# CONSTRUCTION PLANS FOR CARRIAGE MEADOWS NORTH FILING NO. 1 STREET, STORM WATER, AND SANITARY SEWER CONSTRUCTION PLANS

**PROJECT:**  
CARRIAGE MEADOWS NORTH FILING NO. 1  
LORSON RANCH  
EL PASO COUNTY, COLORADO

**COVER SHEET**  
STREET, STORM, WATER, SANITARY  
SEWER CONSTRUCTION PLANS

**TYPICAL SECTION 50' R.O.W.  
RESIDENTIAL URBAN LOCAL**  
NOT TO SCALE

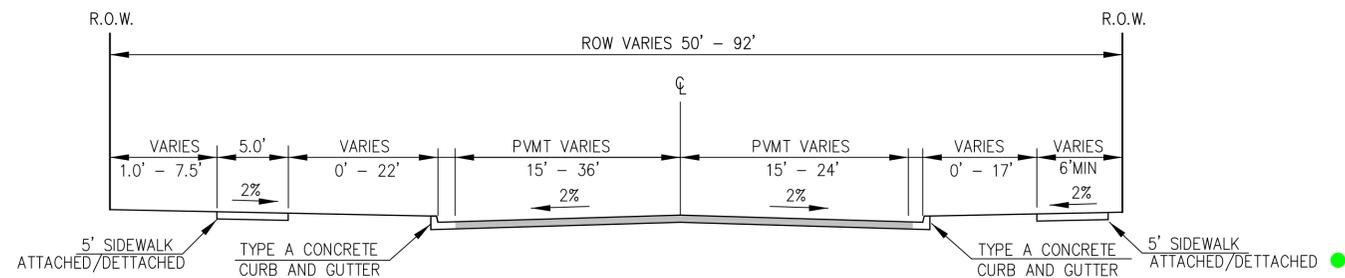
where is this?

DATE: DECEMBER, 2017  
PROJECT NO. 100.002  
SHEET NUMBER C6.1  
TOTAL SHEETS: 41

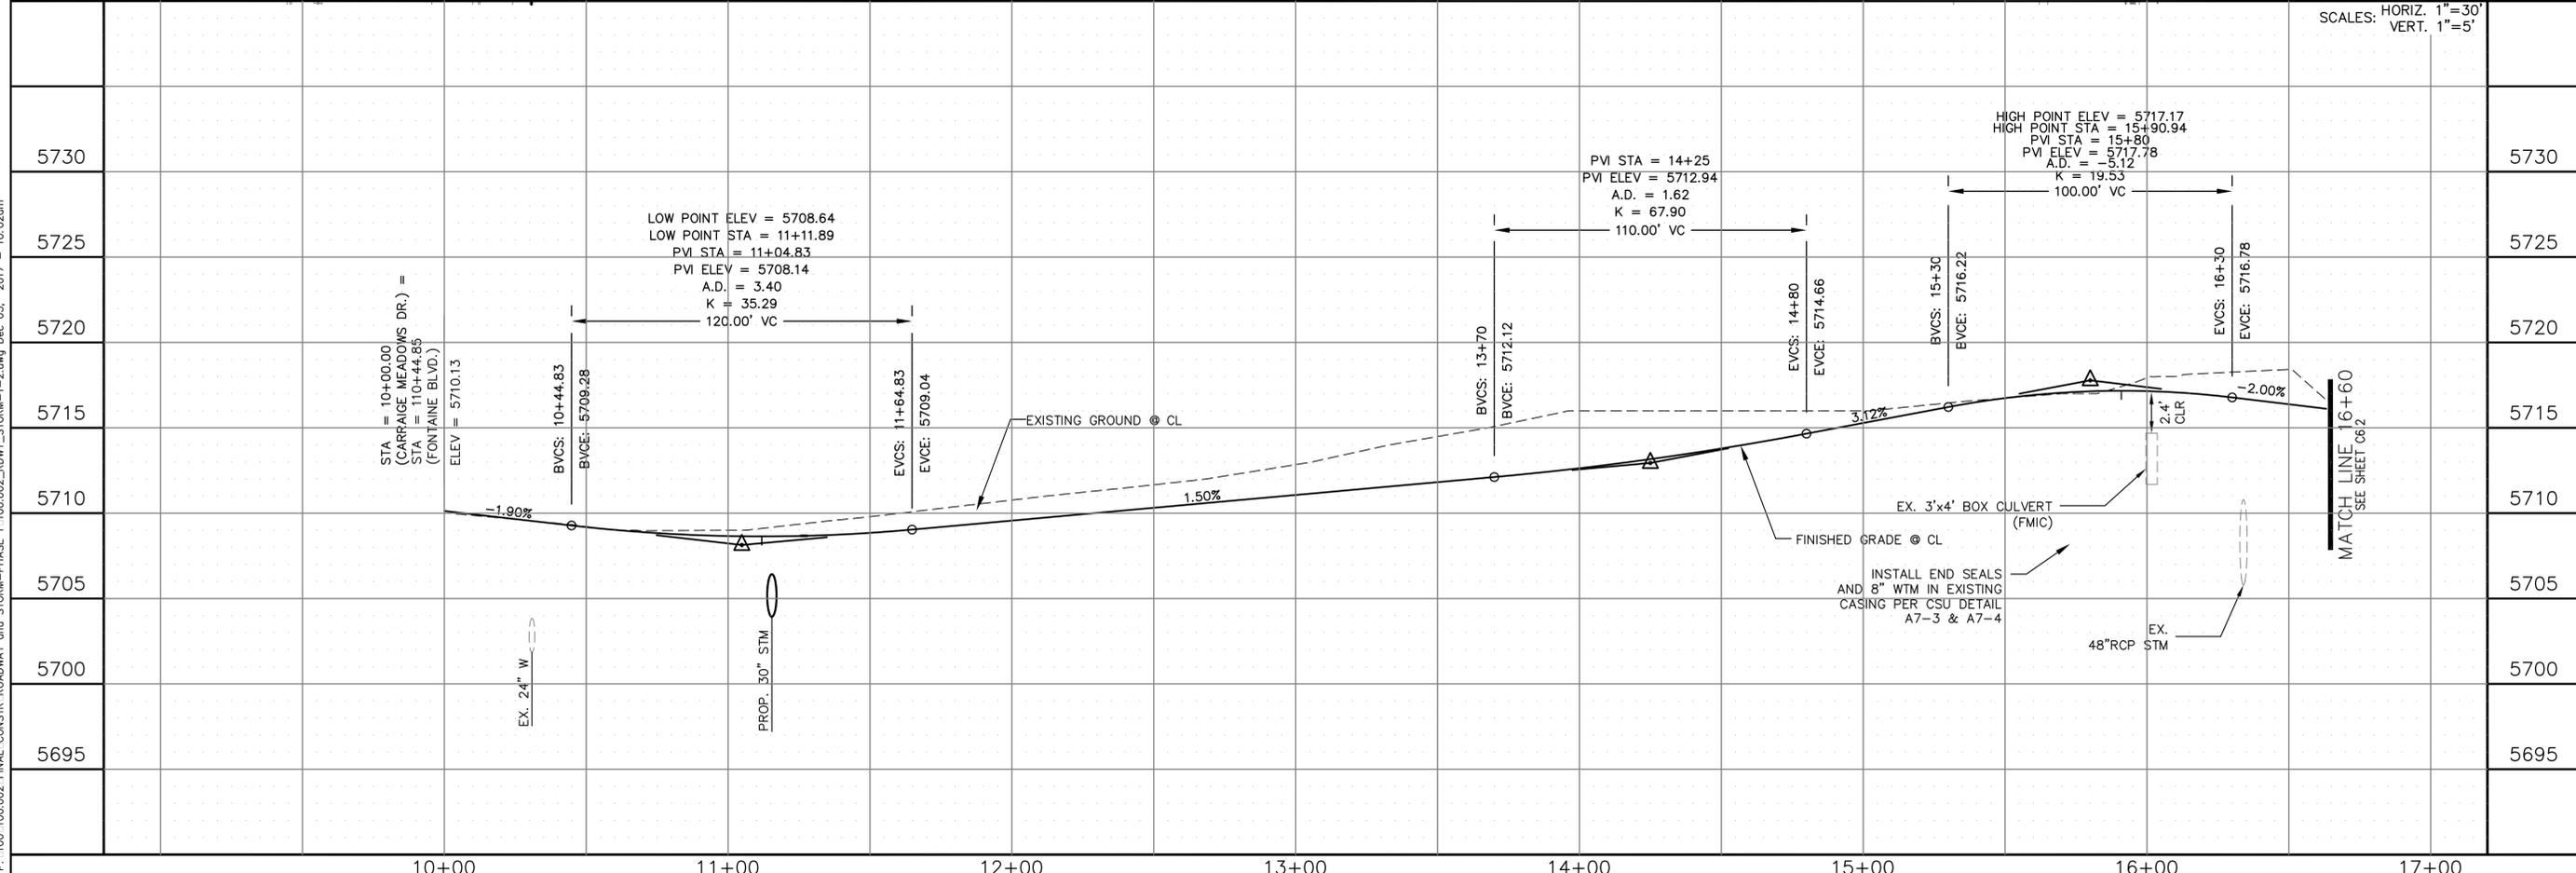
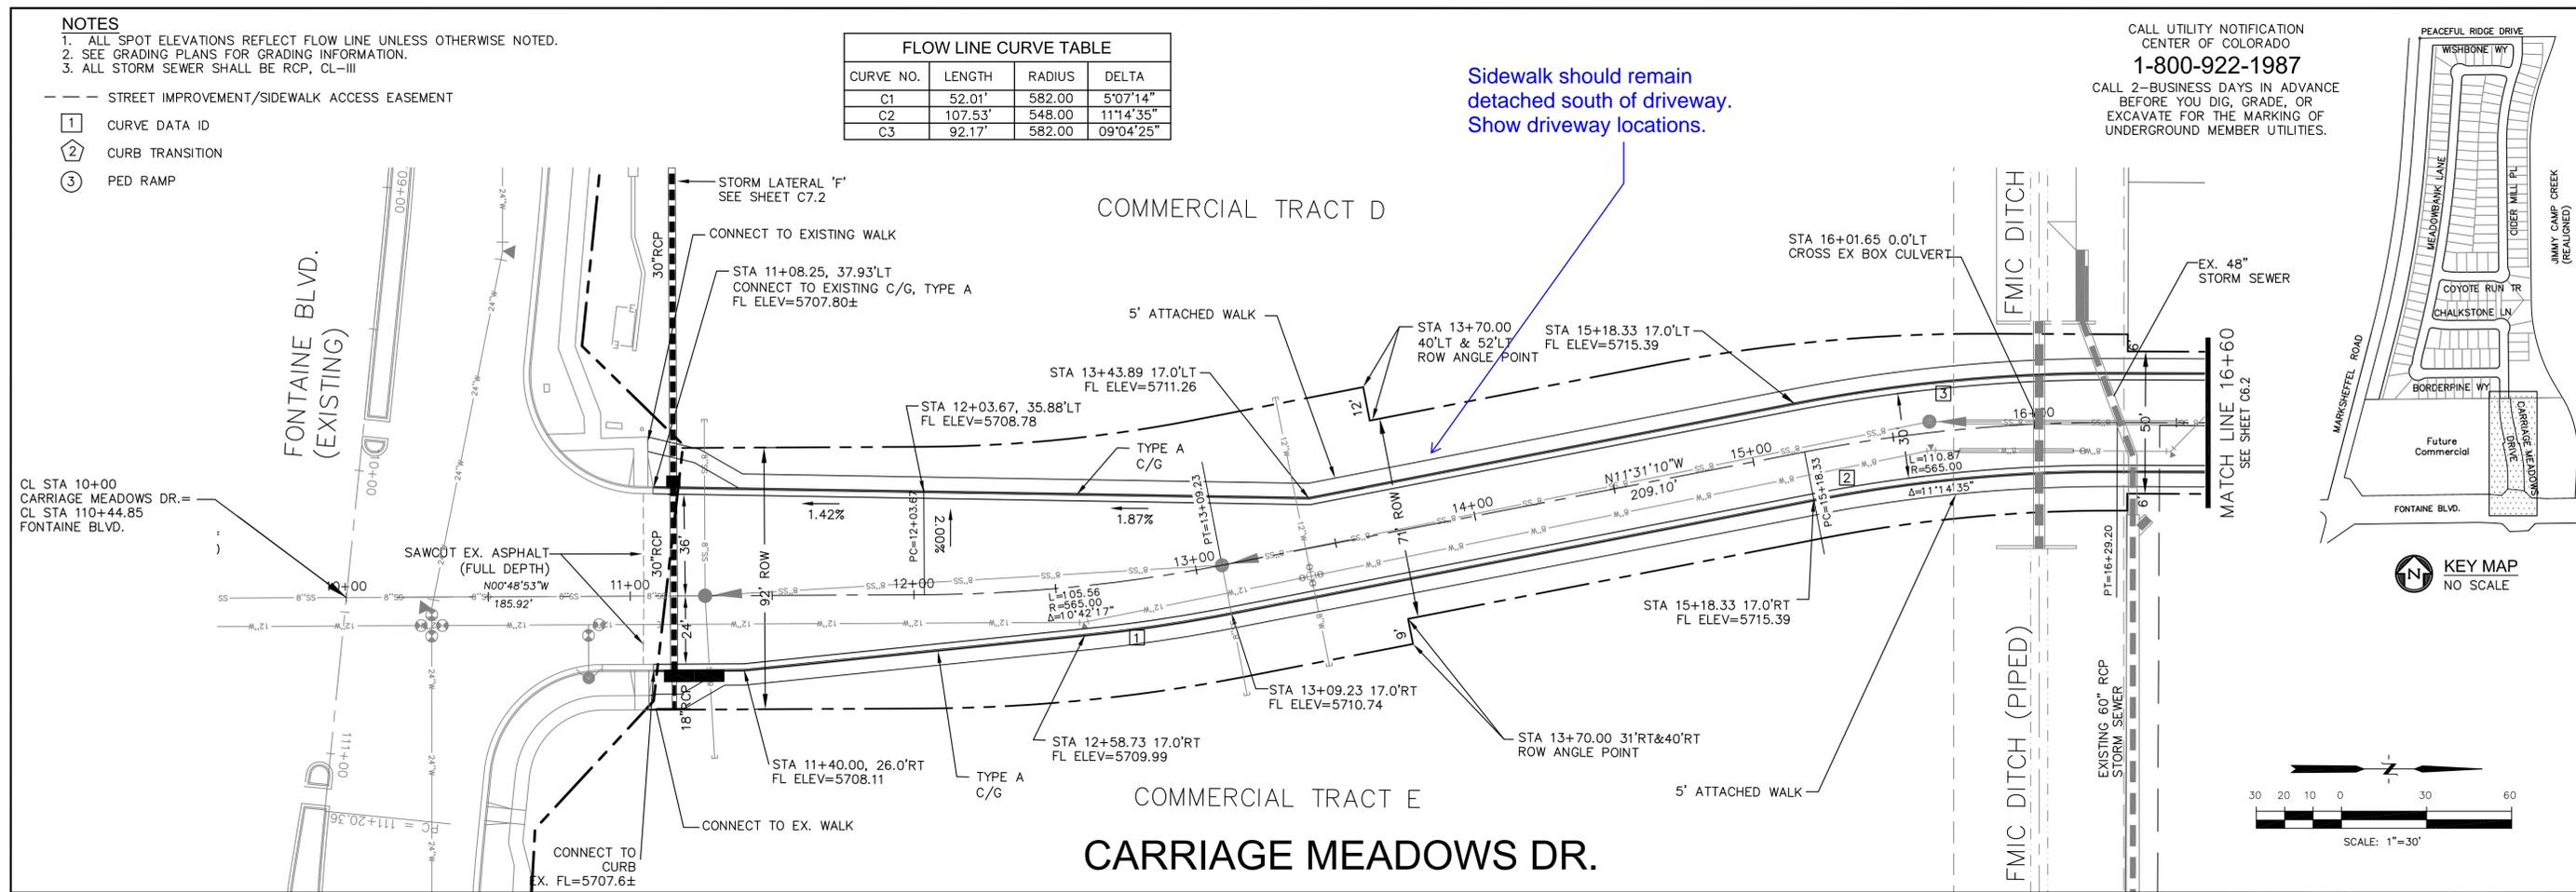
Sidewalk should remain detached south of driveway. Show driveway locations.

STREET PLAN AND PROFILE  
STA 226+79 TO STA 233+09  
MARKSHEFFEL ROAD

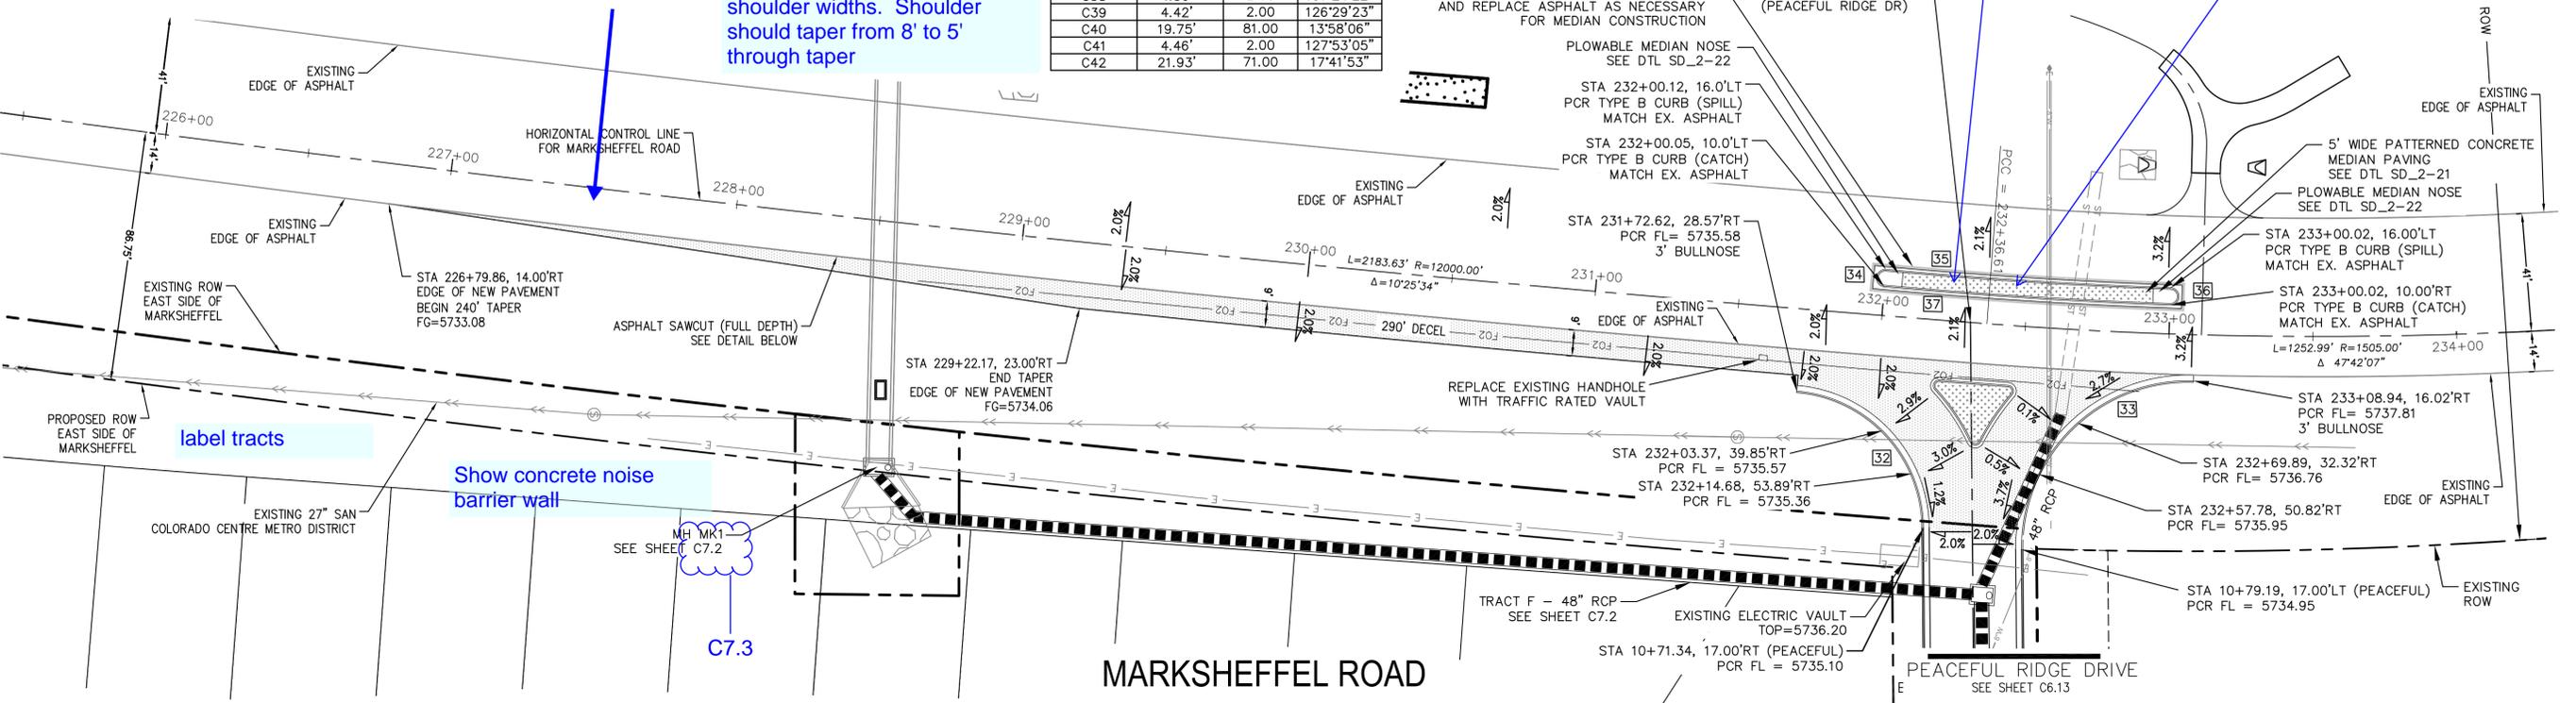
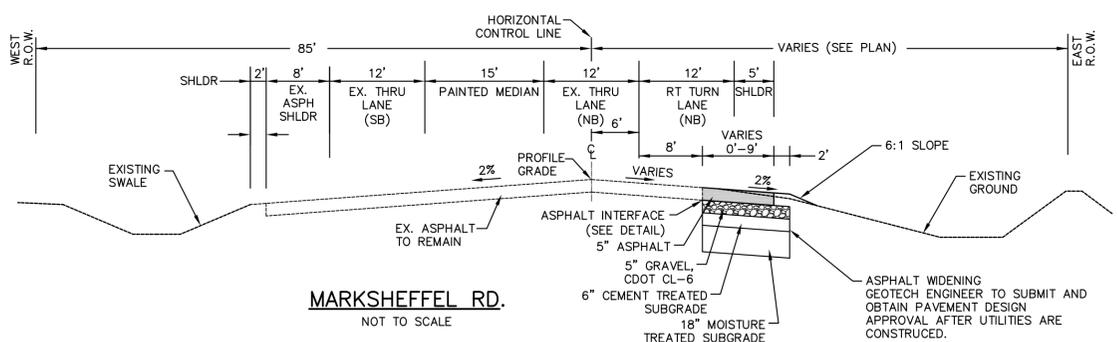
Provide detailed median island plan and cross-section.  
This island needs to be longer each way.

Show concrete noise barrier wall

**CARRIAGE MEADOWS DR.**

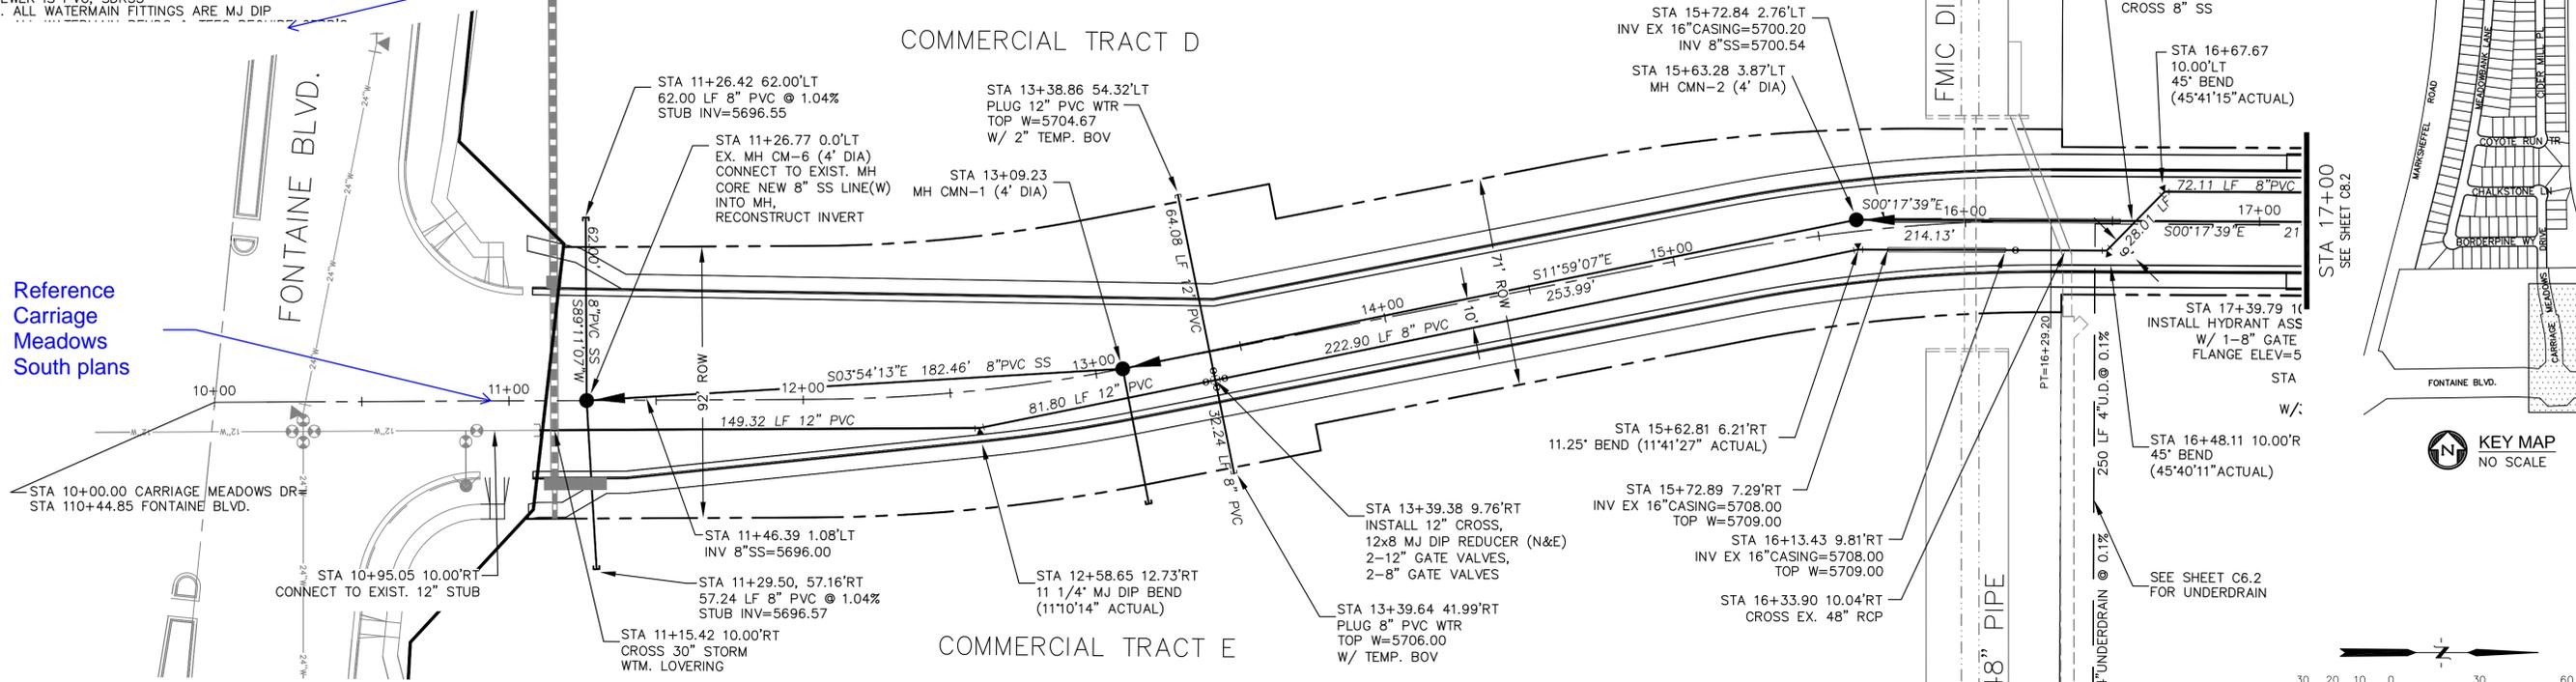
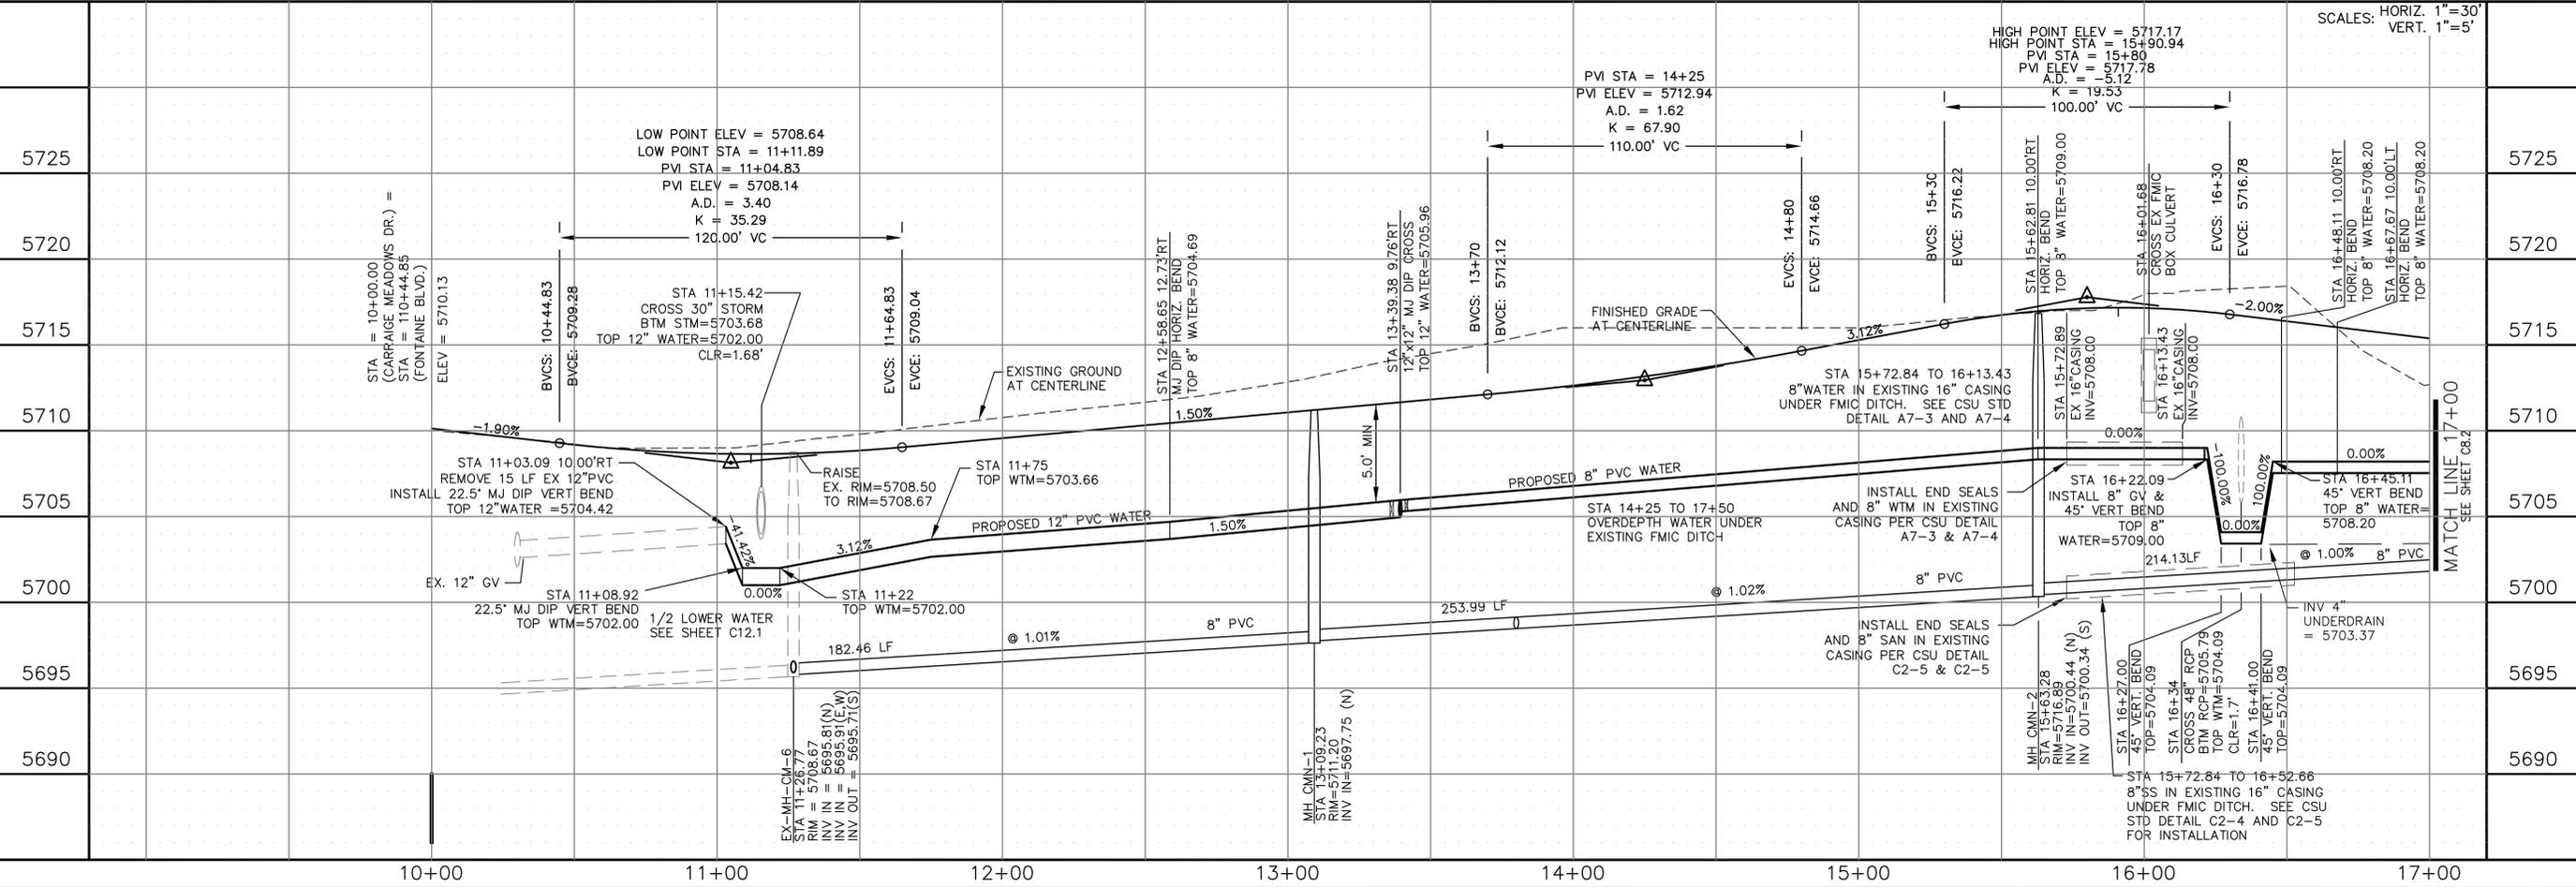
Reference Carriage Meadows South plans
